**CHABOT-LAS POSITAS  
COMMUNITY COLLEGE DISTRICT  
PURCHASING DEPARTMENT**

**Addendum No. 4  
INVITATION TO BID No.: B20/21-08  
Agriculture Science, Horticulture Facility Project**

CLPCCD - LAS POSITAS COLLEGE  
**AGRICULTURE SCIENCE HORTICULTURE FACILITY**  
3000 CAMPUS HILL DRIVE,  
LIVERMORE, CA 94551

**A101**

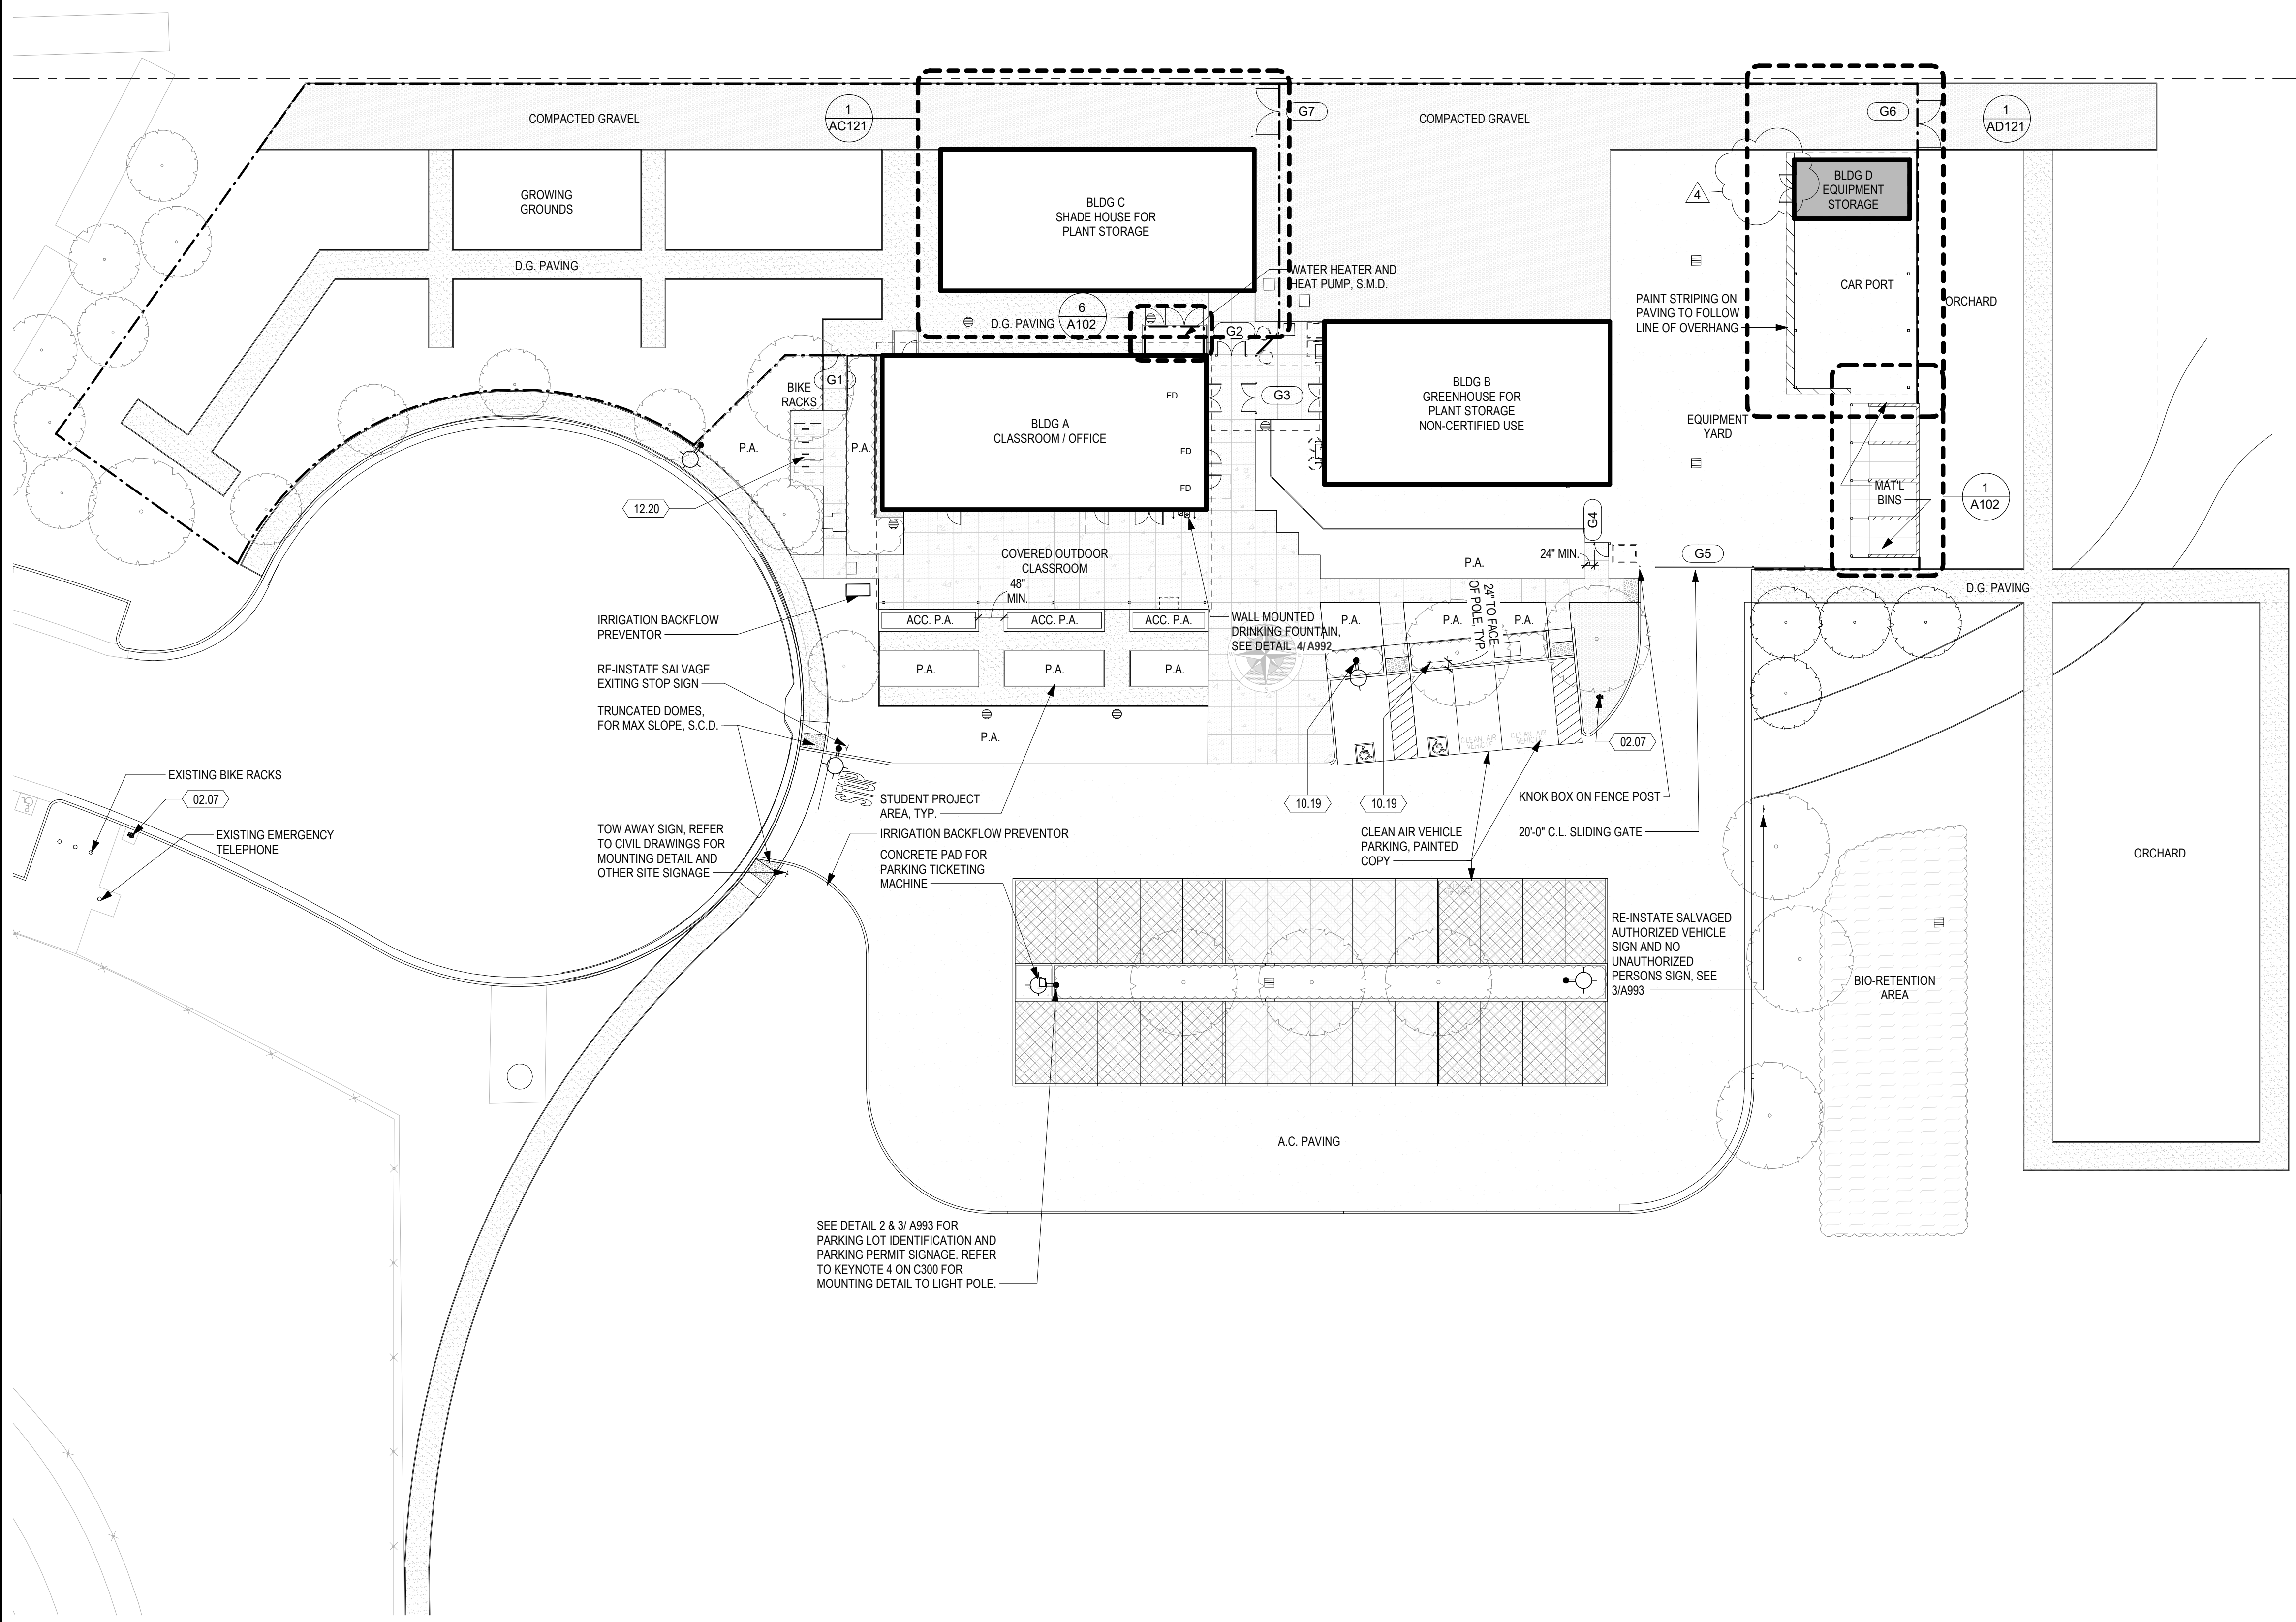
- e. Hardware Group No. 20 – Vehicle Gates - Renamed to Hardware Group No. 19 – Vehicle Gates.
3. **Sheet A101 – Site Plan:** Delete Gate No. 8 from the Gate Schedule.

AA121

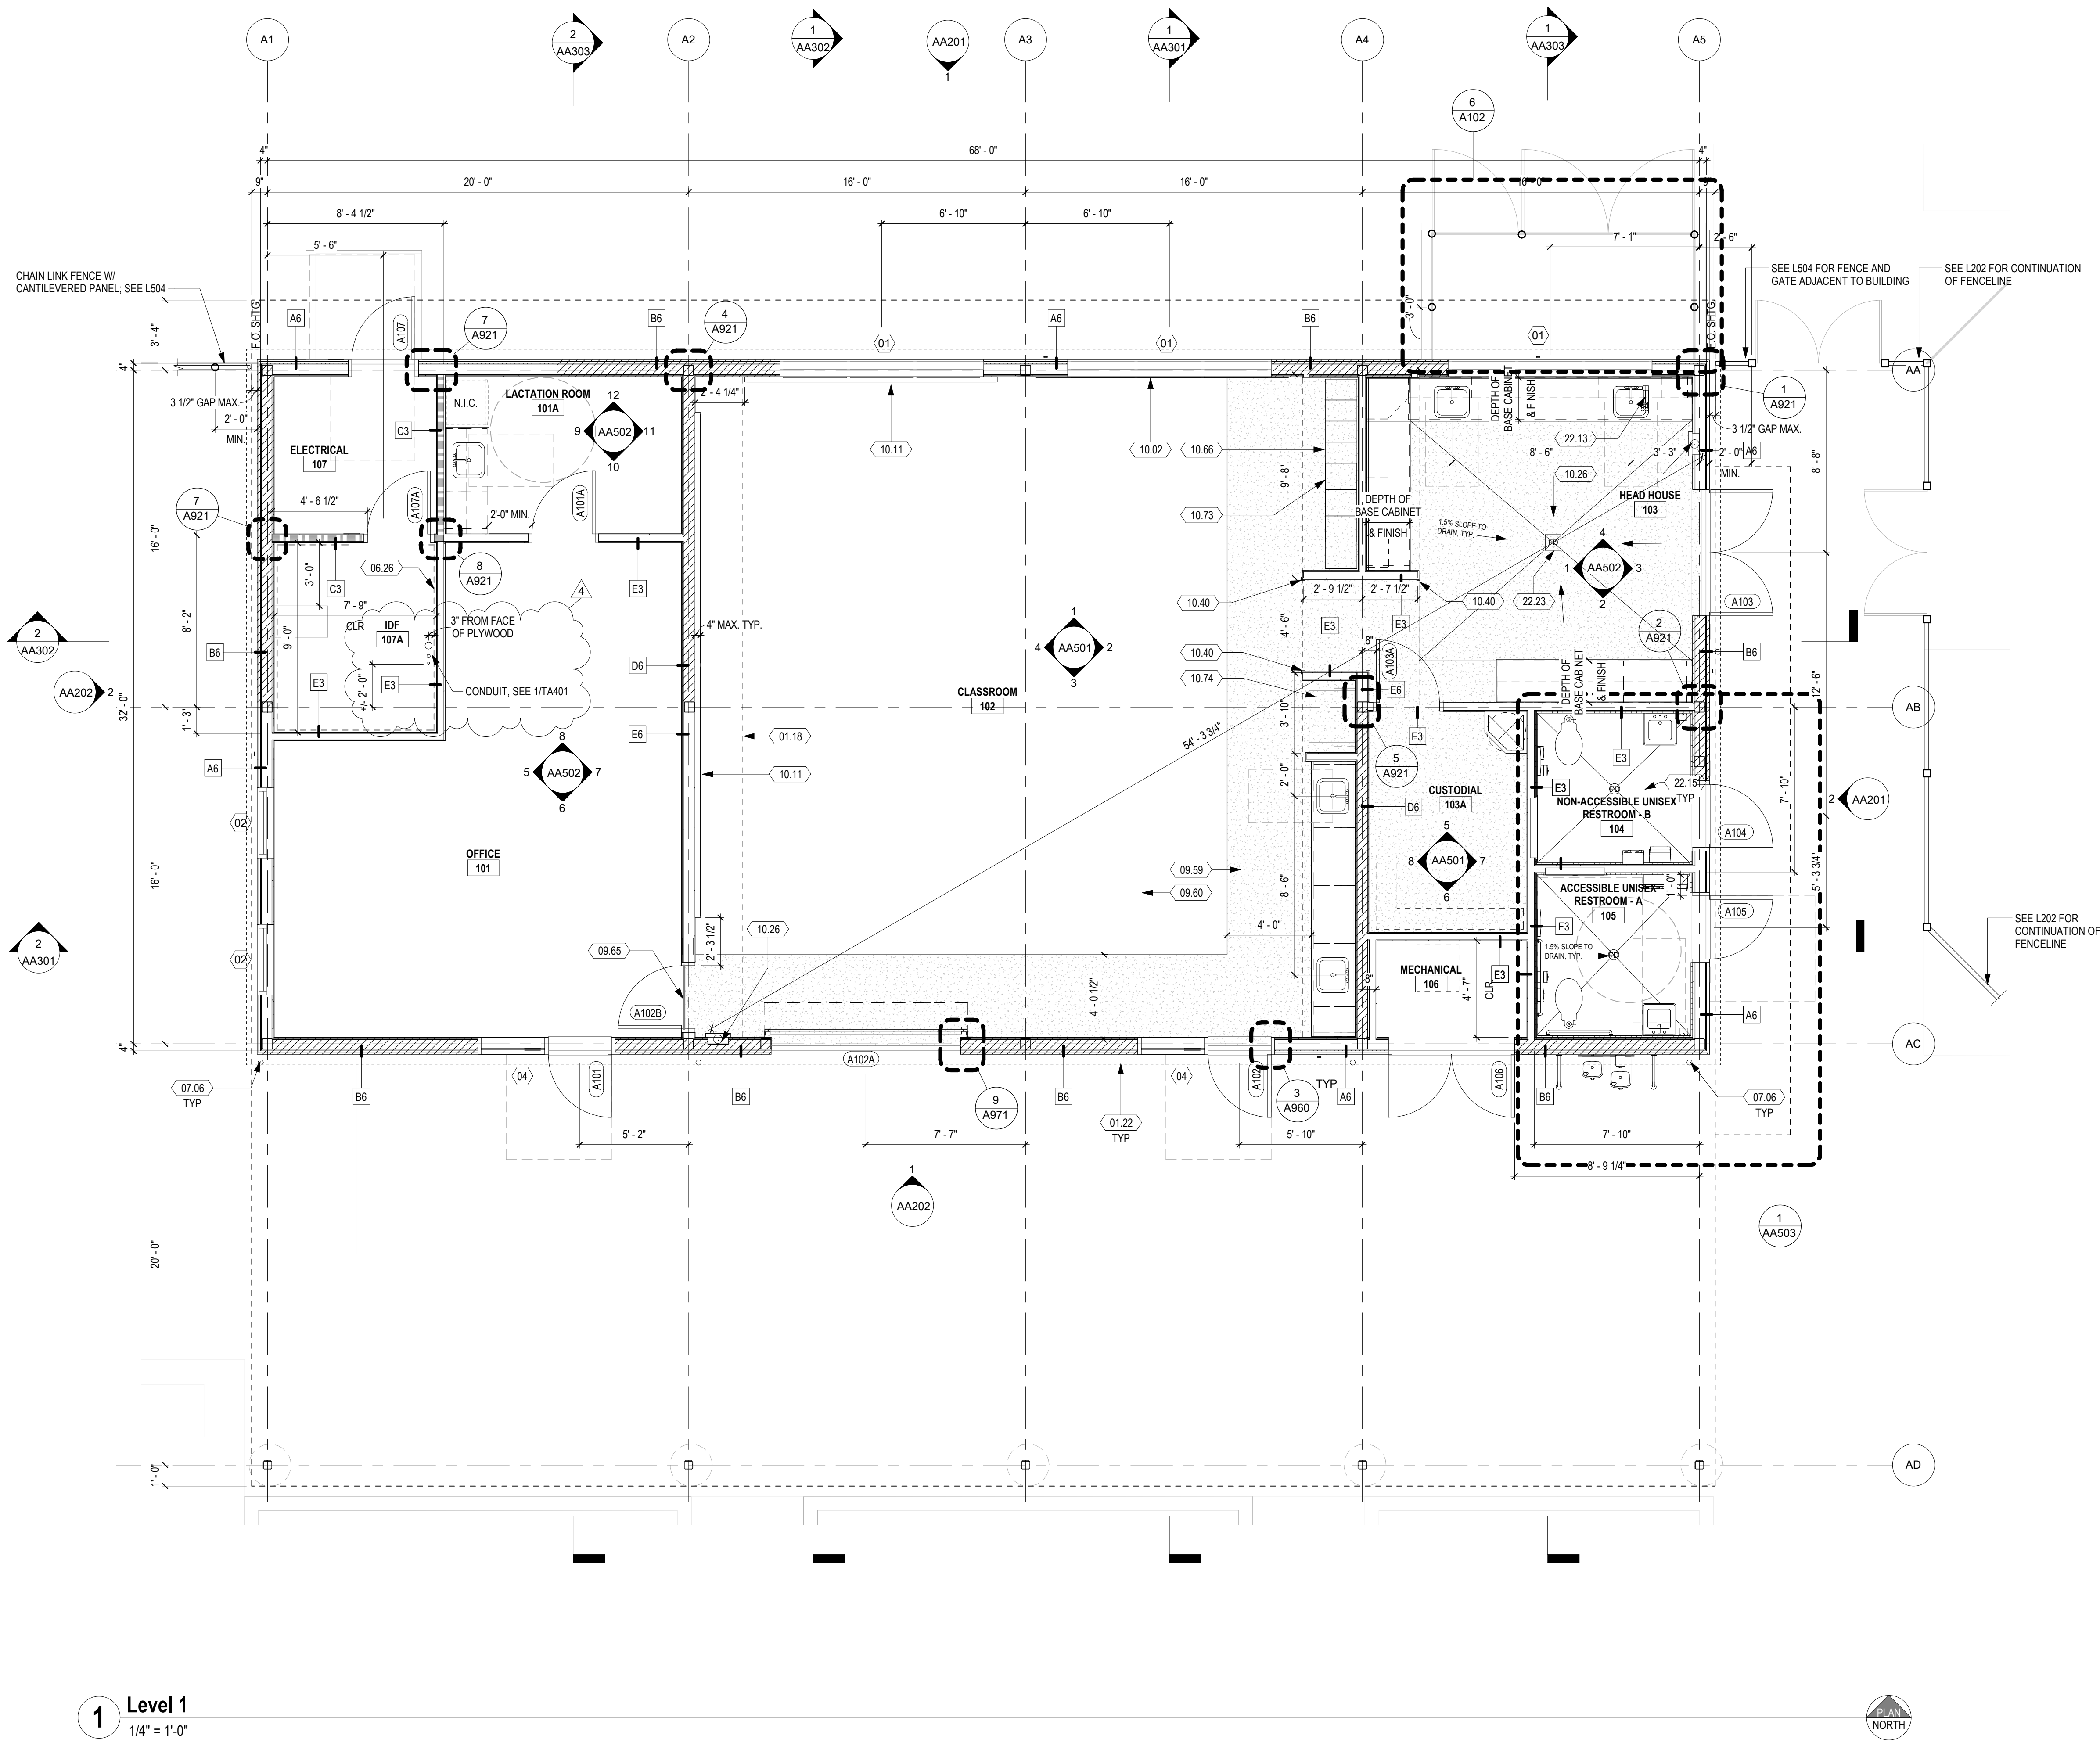
4. **Sheet AA121 – Classroom Building Floor Plan:** Update location of conduit sleeves in IDF Room 107A.
  5. **AA122 – Classroom Building Signage & Existing Plan:**

**AA122**

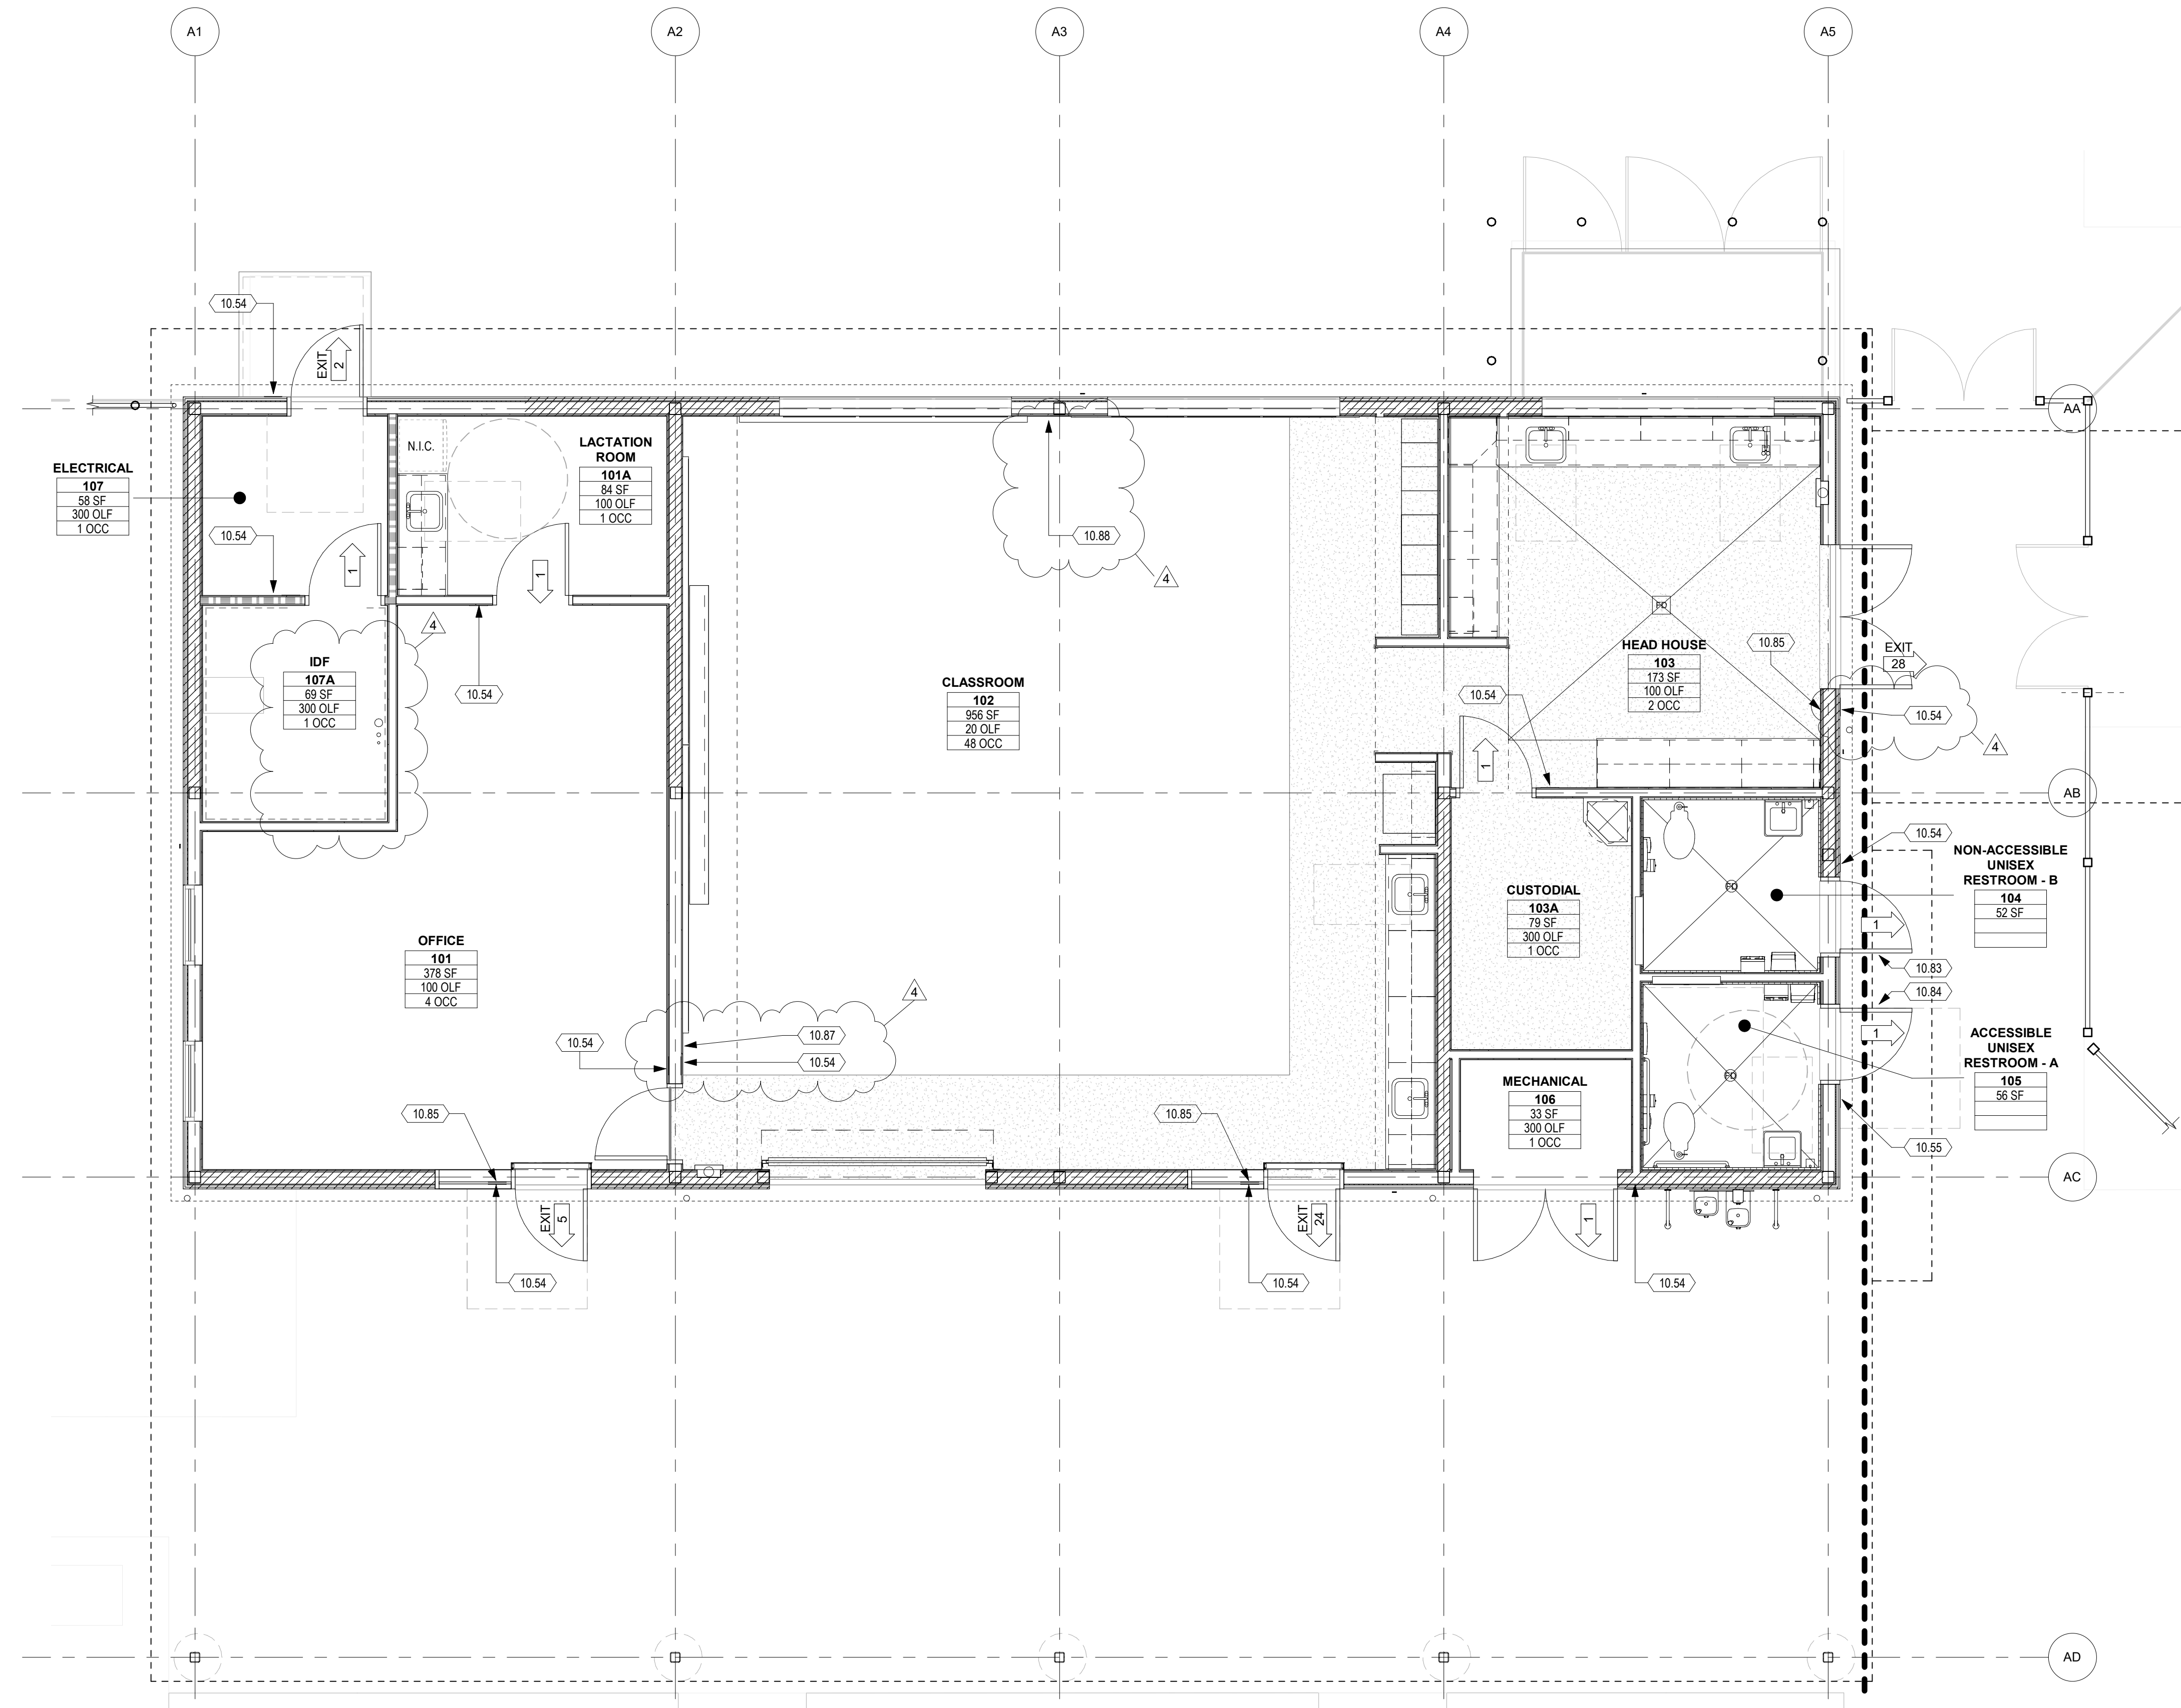
- a. Revised signage type at Door A102B.
    - b. Move signage location at Door A103.
    - c. Deleted unused Keynote 10.86.
    - d. Background update for conduit sleeves in IDF Room 107A.

- e. Updated location of Max. Occupancy signage to match elevation.
  6. **Sheet AA141 – Classroom Building Reflected Ceiling Plan:**
    - a. Depicted exit lights.
